# HUGHES SERVICE INFORMATION NOTICE

NOTICE NO. HN-139

**SUBJECT:** INSPECTION AND REPAIR - STATION 142 TAIL ROTOR CONTROL  
BELLCRANK SUPPORTS, PN 369A3035-11 AND 369A3035-15

**MODELS AFFECTED:** All 500 Model 369 Series Helicopters

Figure 2. Field fabrication of bellcrank support doublers and spacers

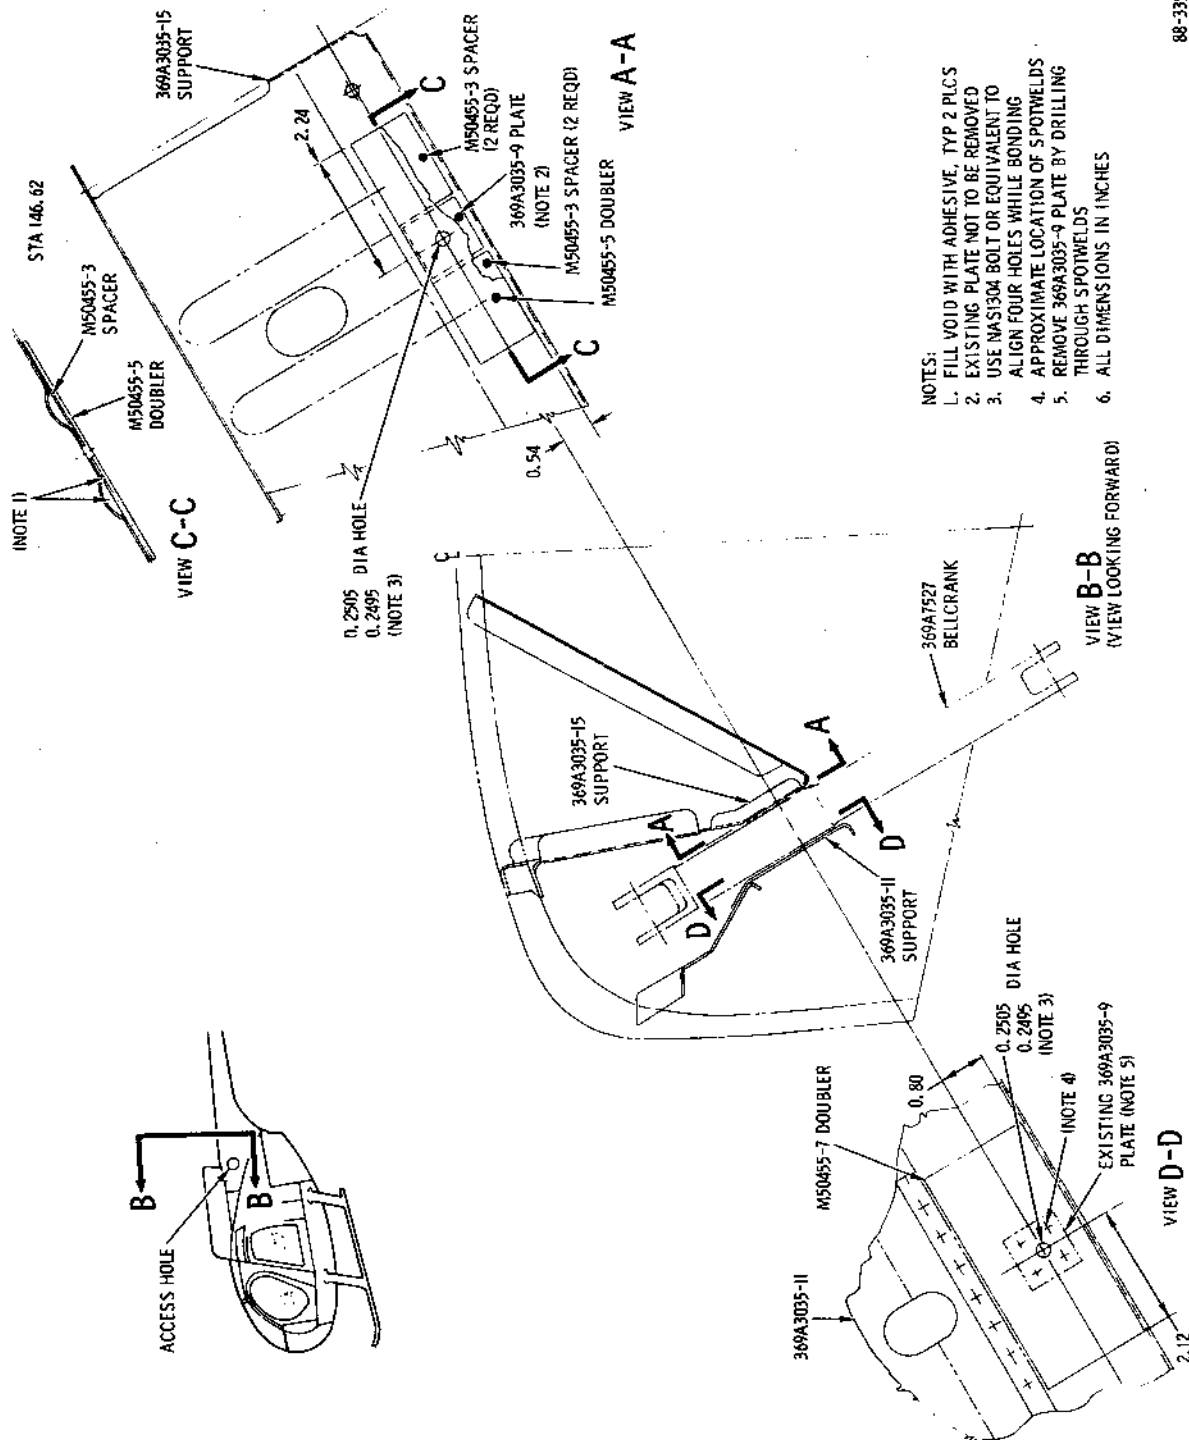
\*May be field fabricated per Figure 2.

Required doublers and spacers may be field fabricated and adhesive primed per Figure 2.

Figure 1. Installation of doublers - tail rotor control bellcrank supports

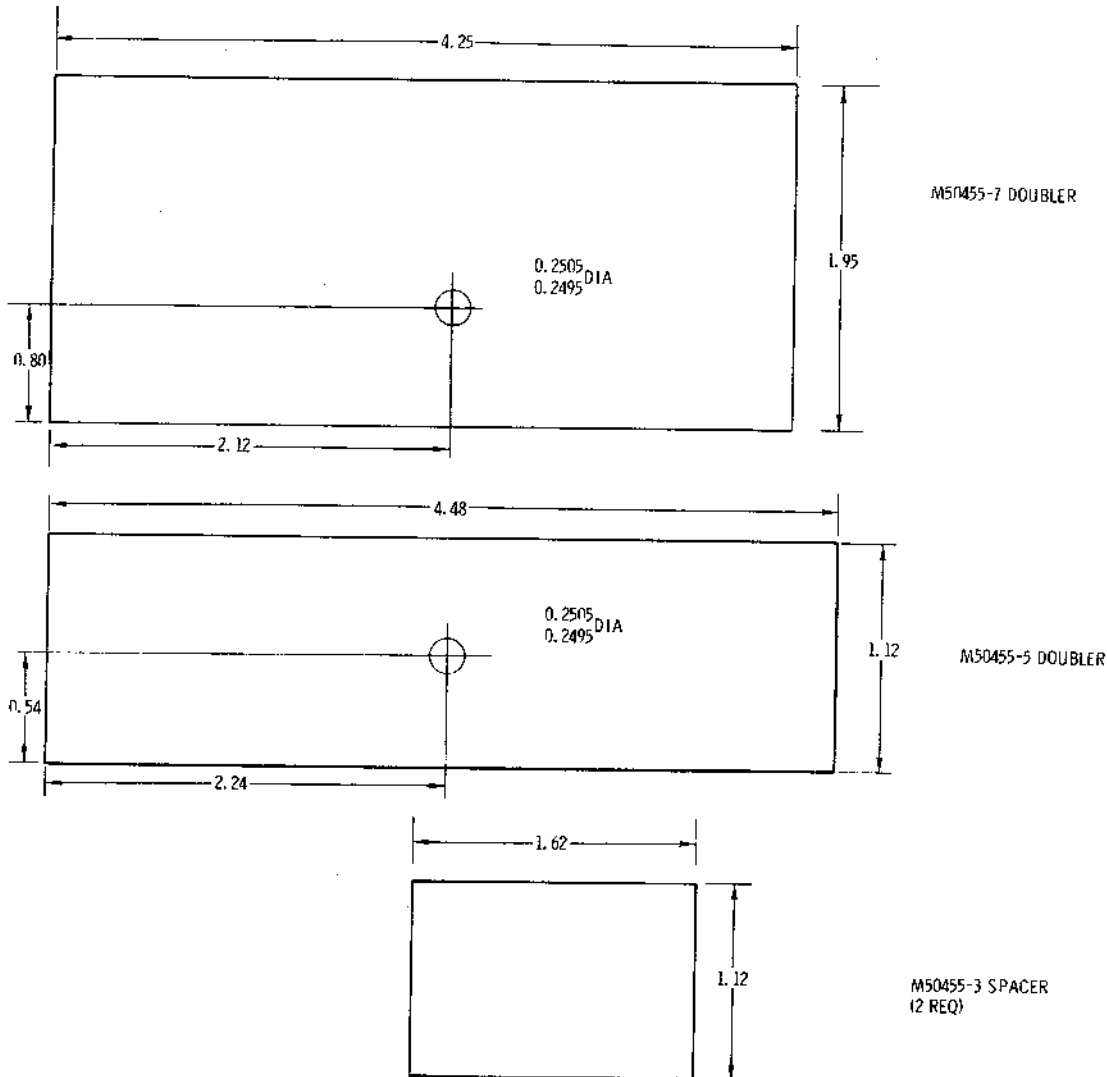
b. Using bright light and mirror, visually inspect PN 369A3035-9 doublers on bellcrank supports for cracking or damage. (See Figure 1.) Pay particular attention to the four spot weld spots attaching doublers to bellcrank supports.

b. Remove existing 369A3035-9 doubler from outboard 369A3035-11 bellcrank support, by drilling out doubler spotwelds, 4 places, as shown in Figure 1.

e. Install spacers and doublers as shown in Figure 1. Use NAS1304 bolt or equivalent as alignment pin to align holes while bonding. Coat bolt or pin with bond releasing agent to prevent possible adhesion to structure.

Part II of this Notice provides instructions for field repair of the supports if cracking is noted, by installing larger doublers on the supports to provide additional reinforcement at the bellcrank attach area. Rework per Part II of this Notice lifts the requirement for periodic inspection of the bellcrank supports.
